Task Oriented Practice (TOP) 4ESS™ Switch Time Slot Interchange (TSI) Frame Trouble Clearing TOP

- 1.001** This addendum supplements TOP 234-151-012, Issue 6.
- 1.002** This addendum is being issued to update the NTP-003 and DLP-549.

**REPLACE CIRCUIT PACK – TIME SLOT INTERCHANGE (TSI)
 FRAME A-LINK CONTROLLER**

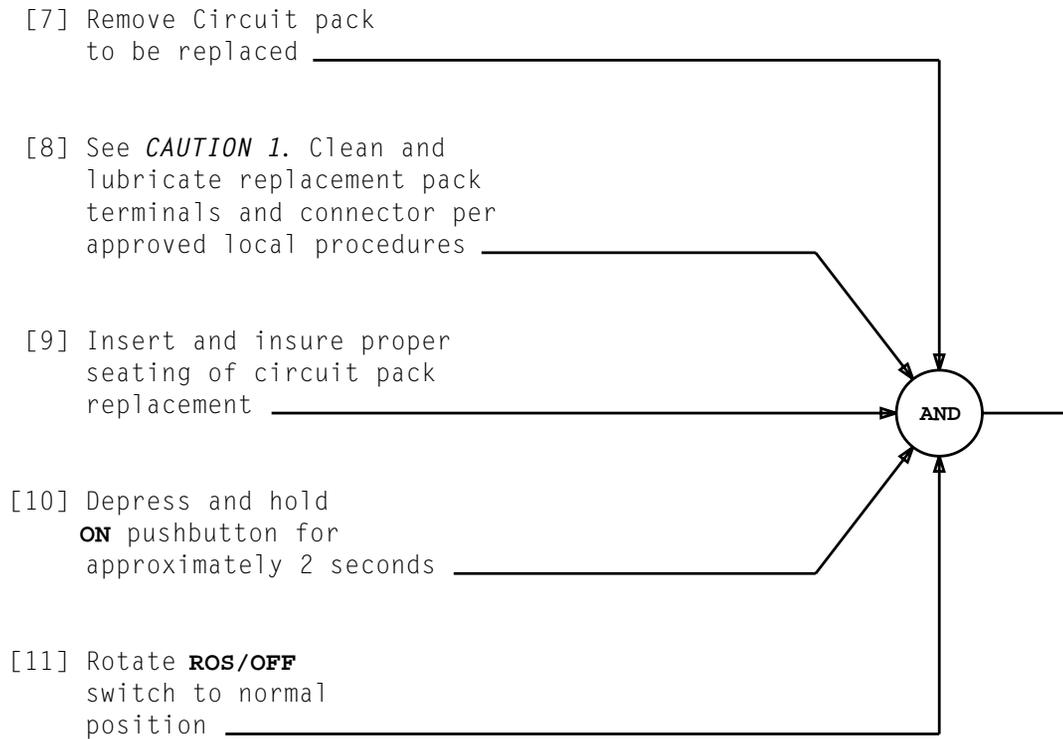
<i>CAUTION 1</i>	
<i>Circuit packs in locations designated FA533 can only be replaced with FA533B or FA533D. Circuit packs designated FA1808 can only be replaced with FA1808 or FA1808C. Failure to comply to this rule will cause increased susceptibility to Transmit Receive Parity Failures (TRPFs) F-levels</i>	
Issue 6	NOV 1999
234-151-012	DLP
PAGE 2 of 2	549
